PETERSBURG HARBOR REHABILITATION

PROJECT No. 69719

AS BUILT

69719
PETERSBURG
NORTH HARBOR
KUPREANOF &
PAPKE LANDING
REPAIRS
Sht 1 of 10

| | STATE OF ALASKA DEPARTMENT OF TRANSPORTATION AND PUBLIC FACILITIES PETERSBURG ALASKA SUPPLY ONLY ITEMS - DETAILS & QUANT. | | | |

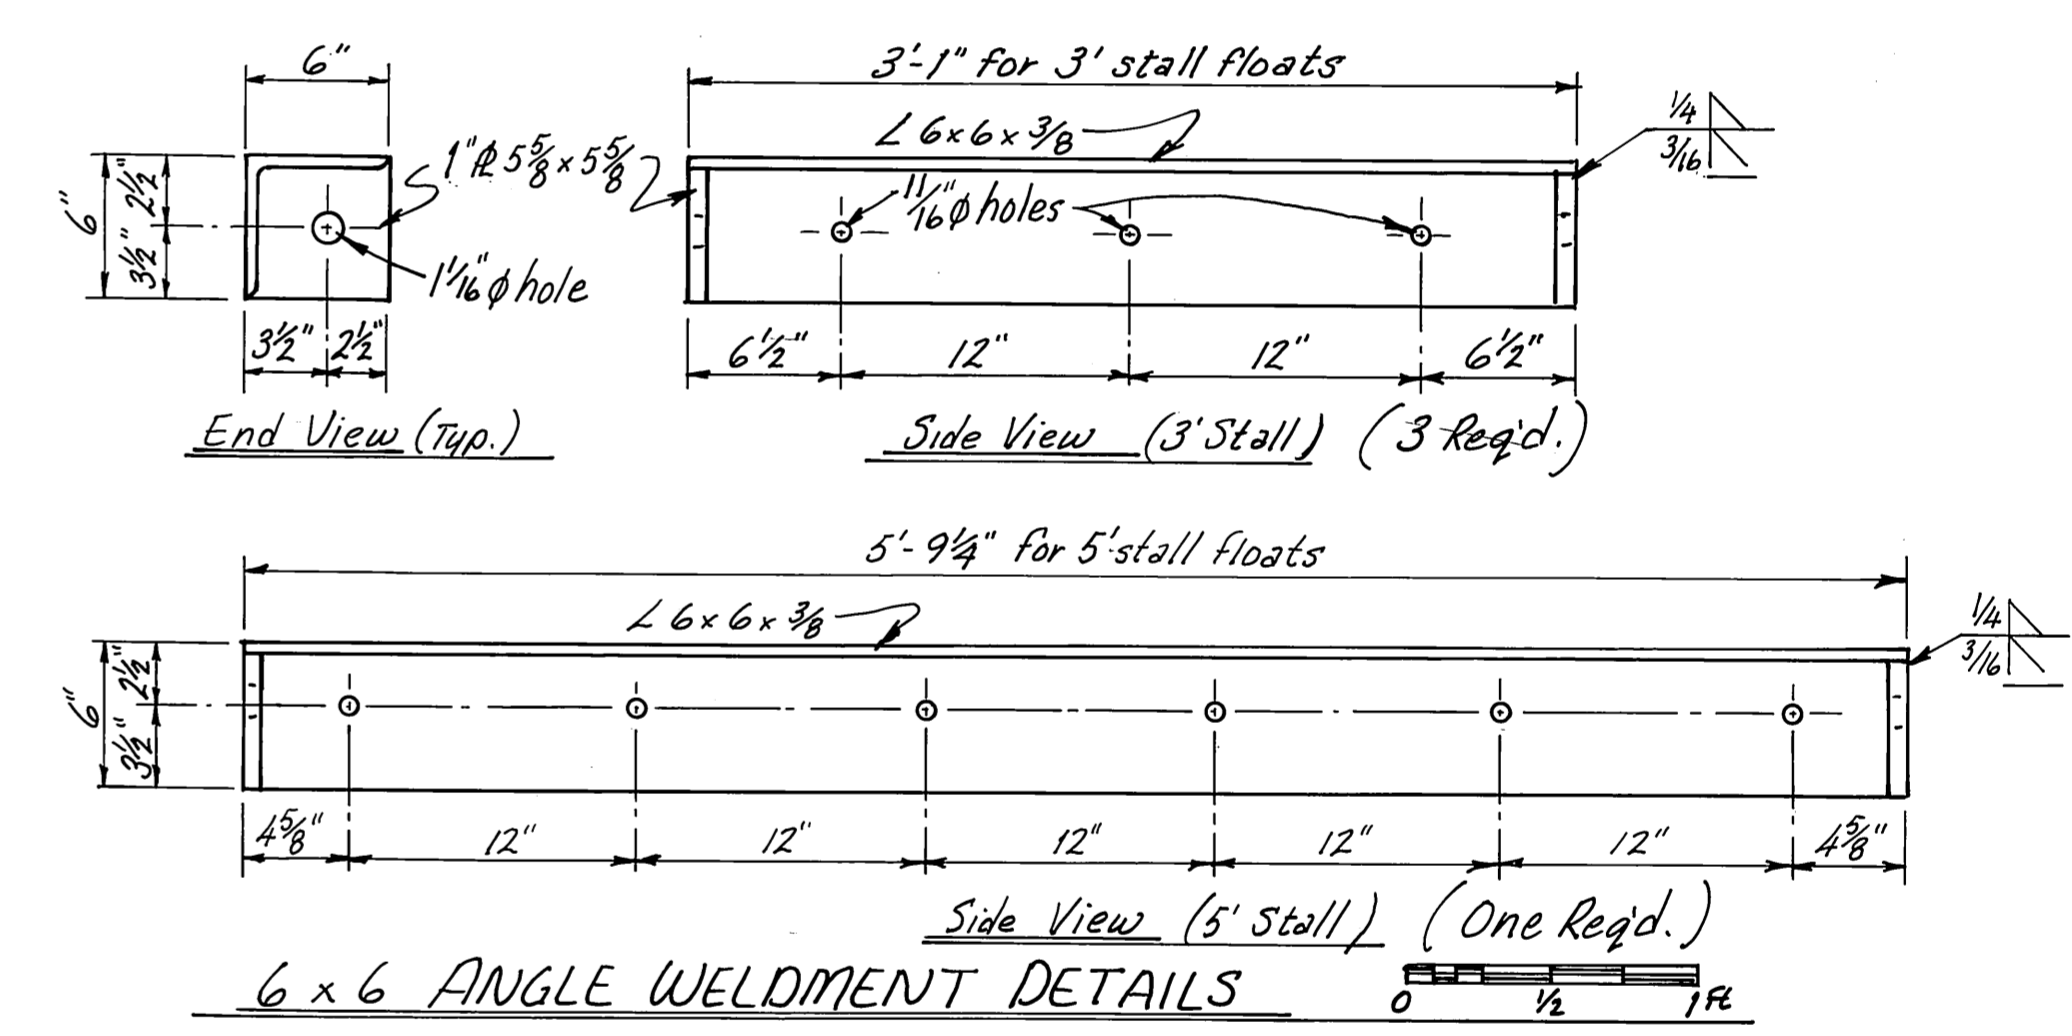
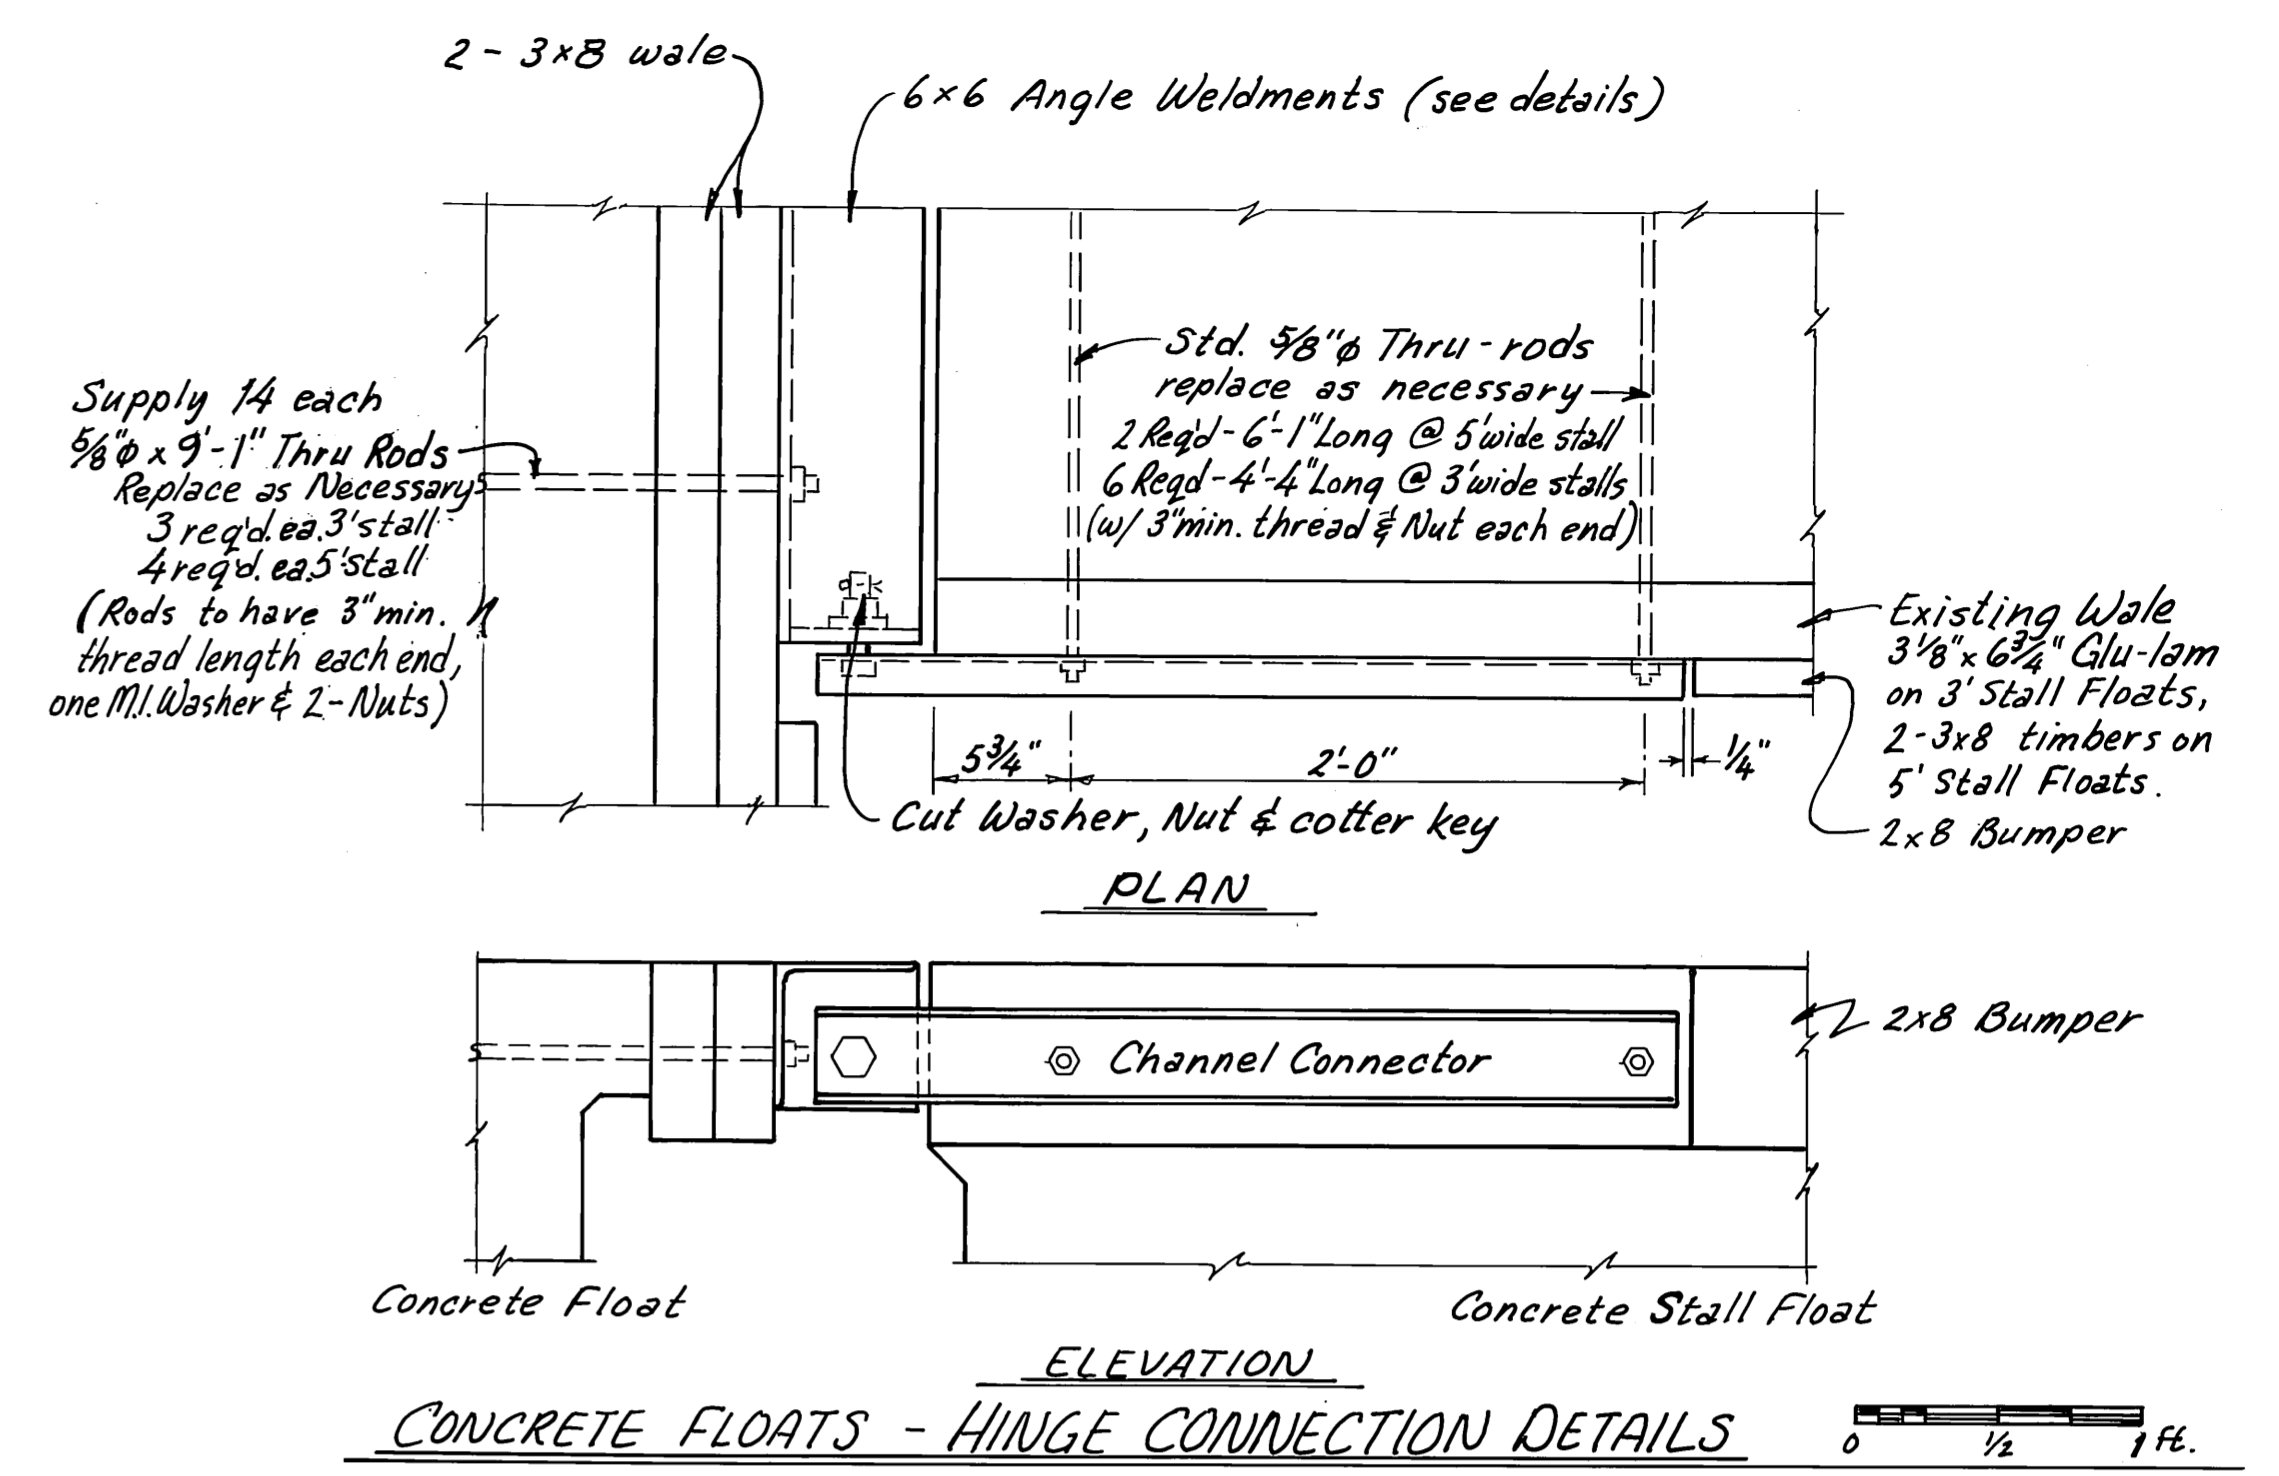
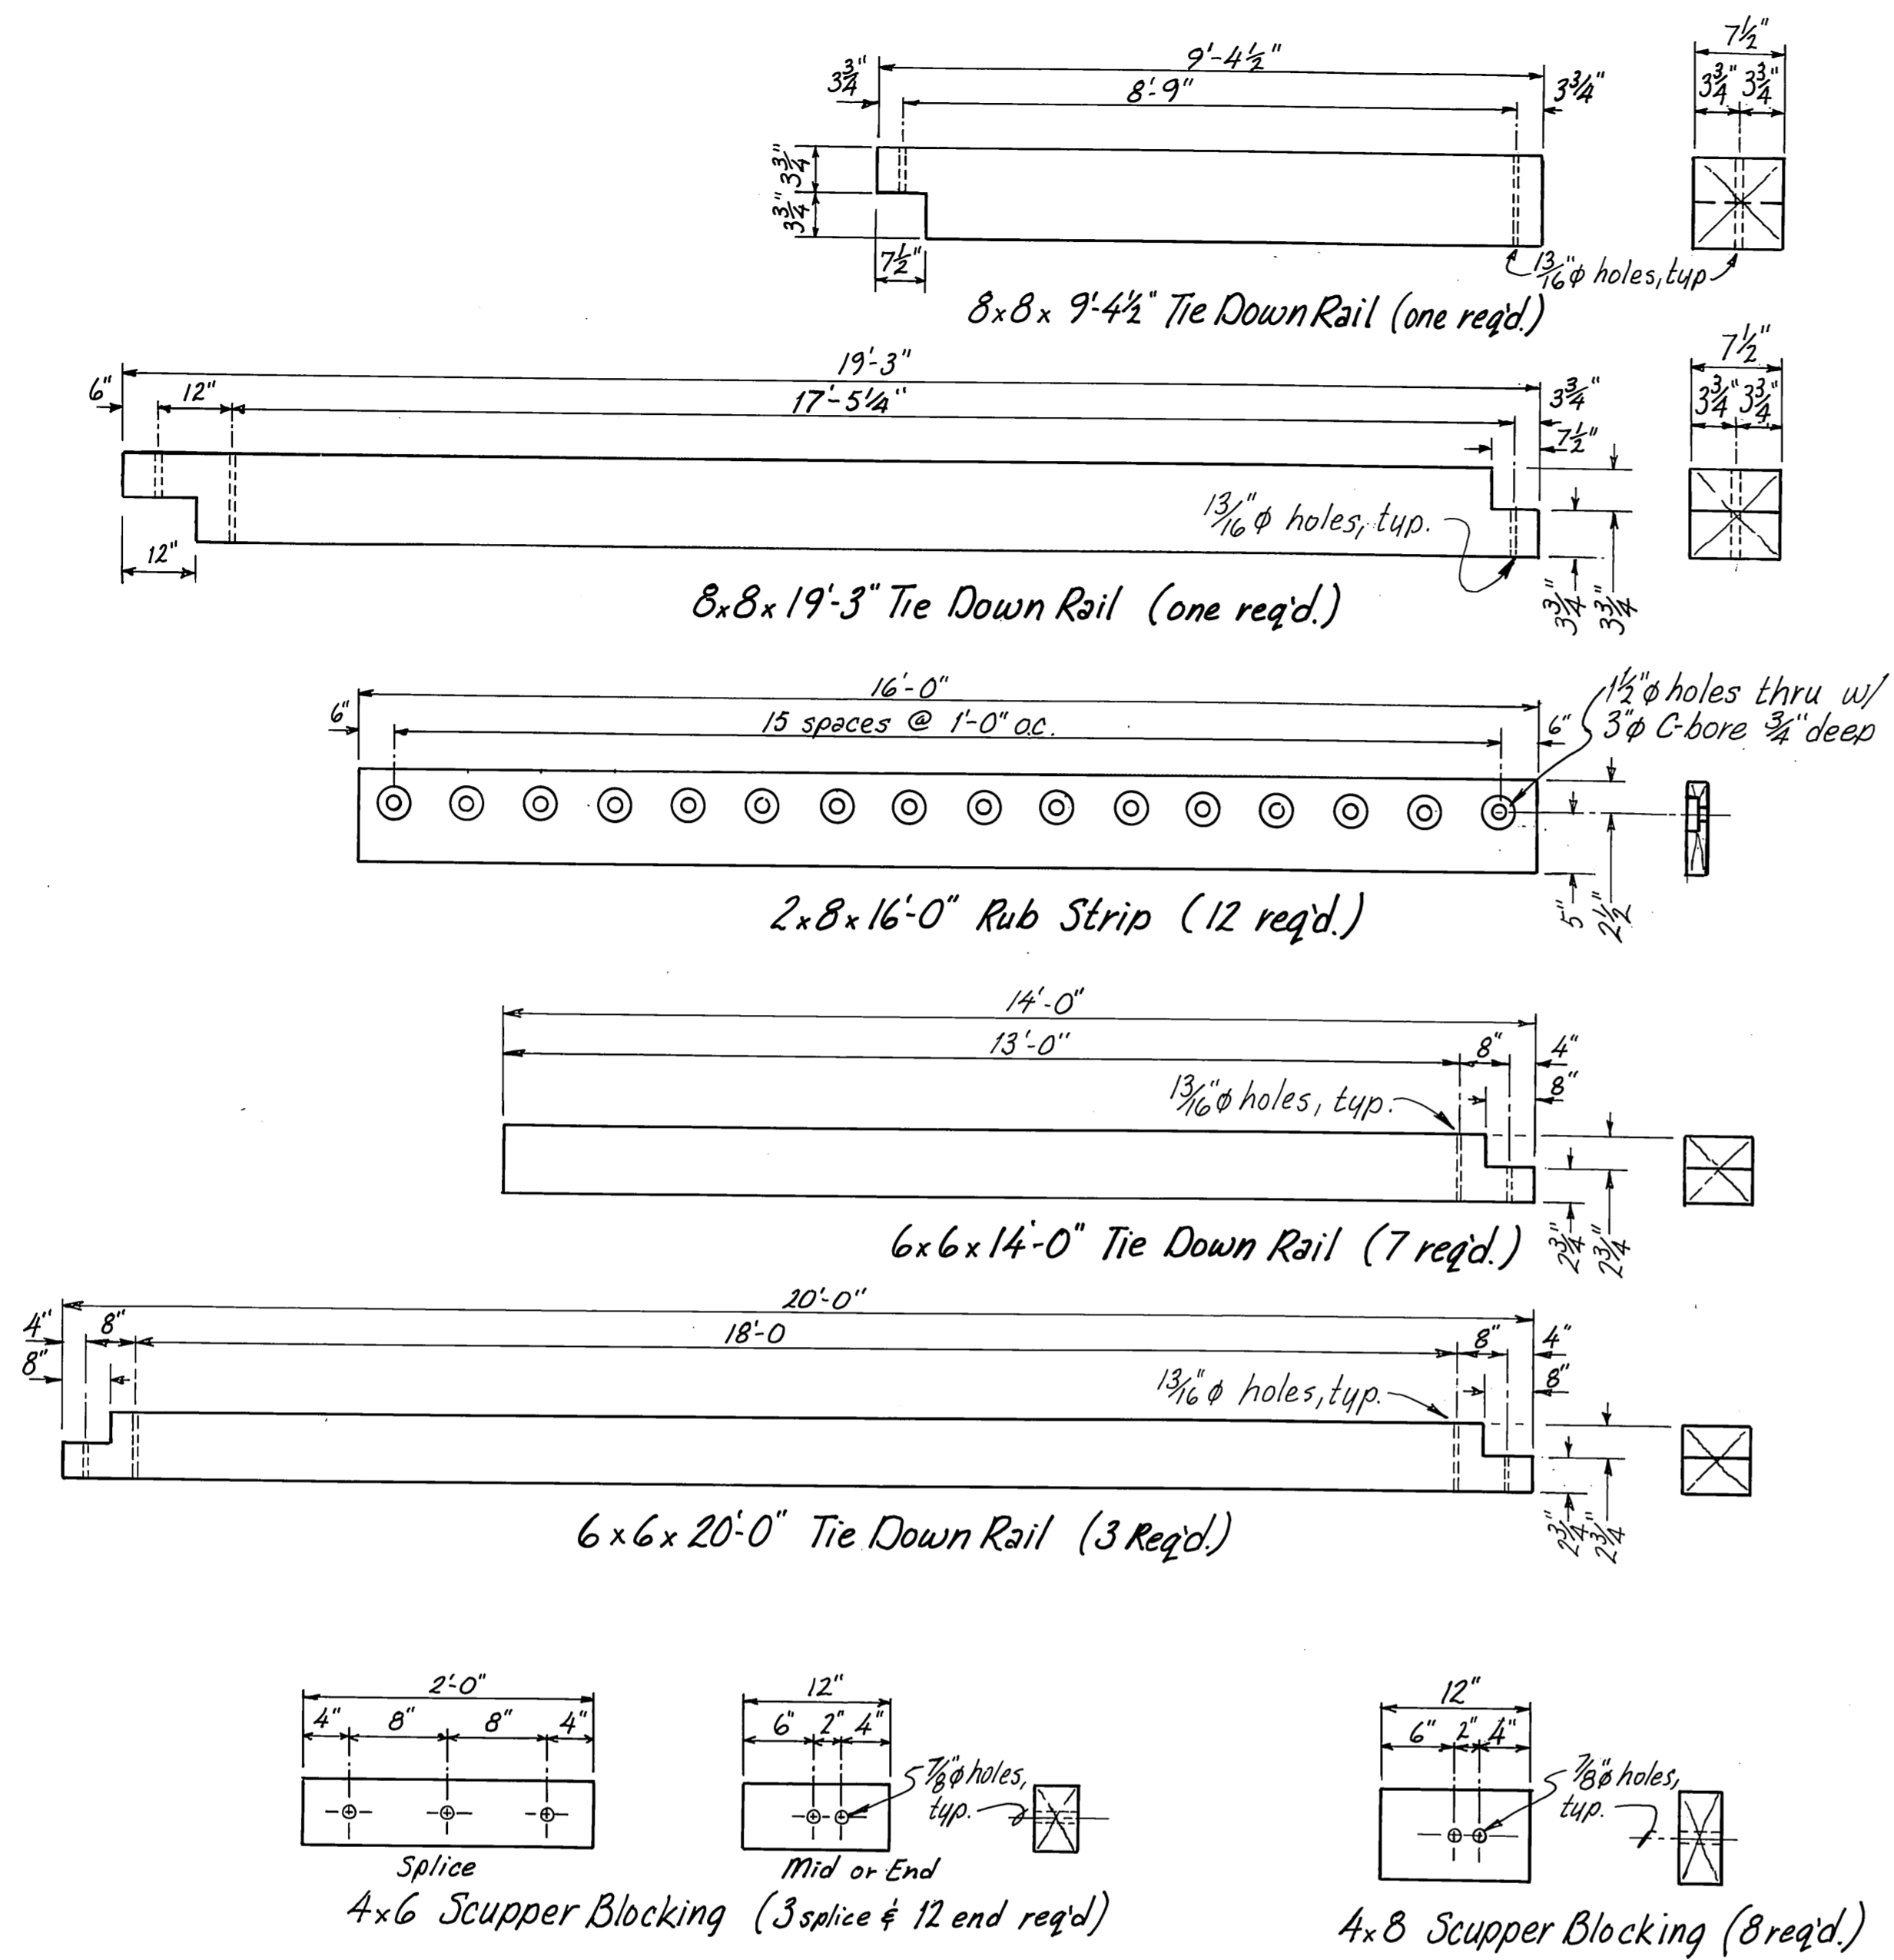
NOTE:
 THESE MATERIALS ARE SUPPLIED IN ADDITION TO ANY MATERIALS CALLED OUT ON OTHER SHEETS OF THESE PLANS. THESE ITEMS SHALL BE COMPENSATED FOR UNDER PAY ITEM 306. THESE ITEMS SHALL BE DELIVERED TO THE HARBORMASTER IN PETERSBURG. This work is being bid as Supplemental "A".
 These items were installed by Contractor under a Change Order - See Note, Sheet 2.
